# CITY OF BANGOR

## Checklist for Land Development Applications

Project: The Maine Woods Subdivision

Applicant: Team Properties, LLC

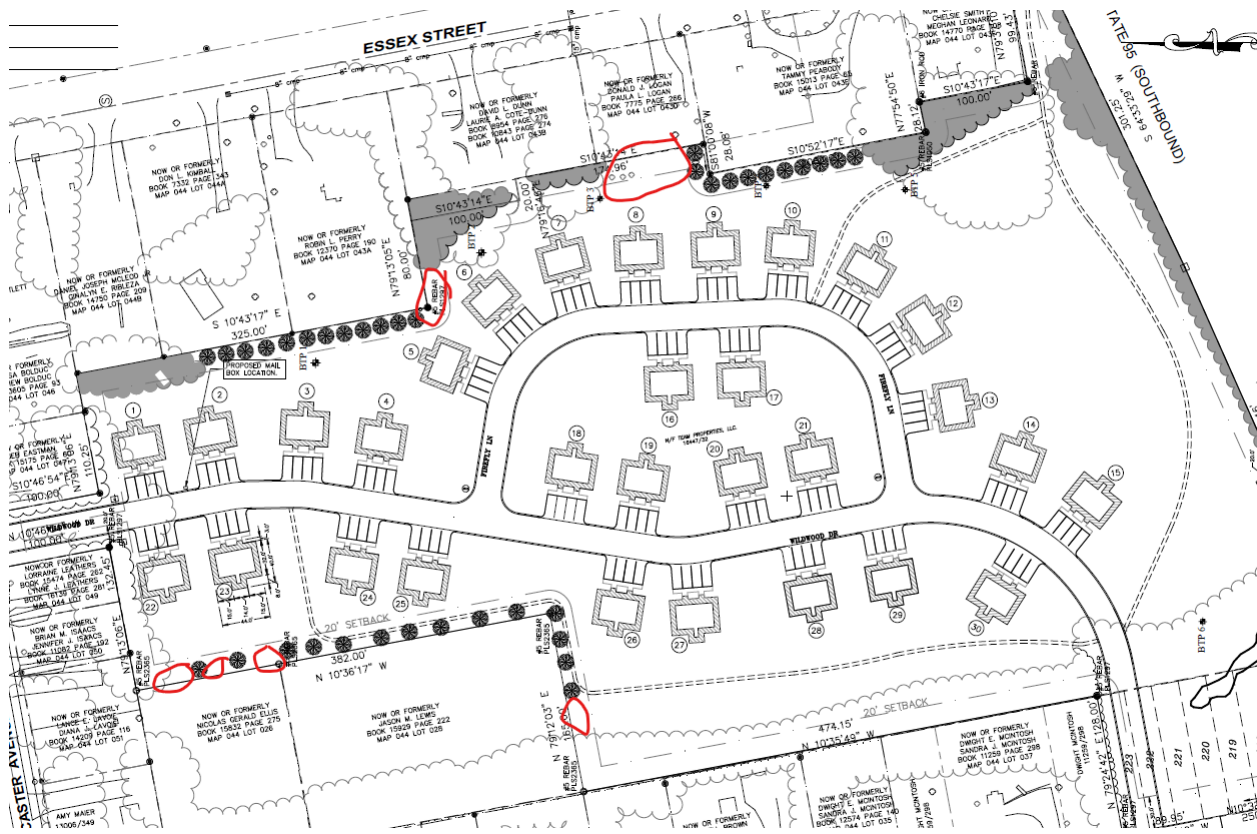
The subdivision plan needs to show the perimeter of all parcels involved in the project; Map-Lot 044-058 is not shown in its entirety.

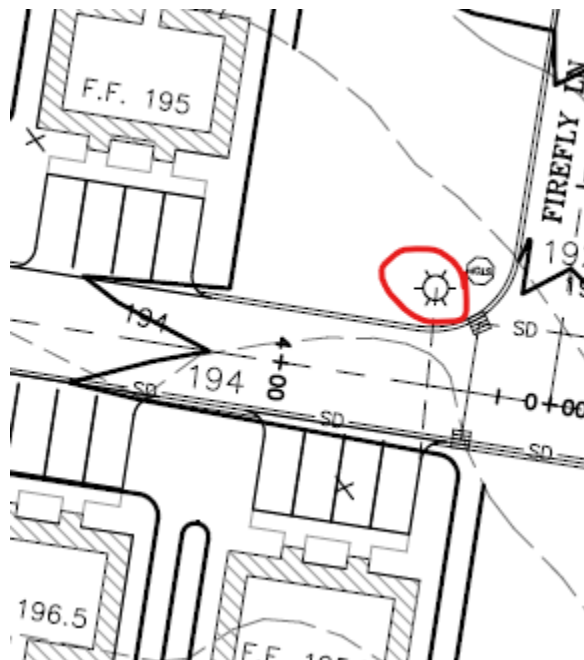
Please provide details on the new buffer plantings sufficient to show that they meet the requirements of Buffertype A (i.e. show what's required for both width of the buffer, as well as numbers of deciduous/evergreen trees and shrubs, and what is proposed for the site). Please also show how they meet the District Site Development Standards.

There are also gaps in some of the vegetation/plantings; the buffering needs to be present along all of the side lot lines. See gaps circled in image below. Please also provide a plant list to ensure the plantings meet the landscaping requirements for Land Development Permits.
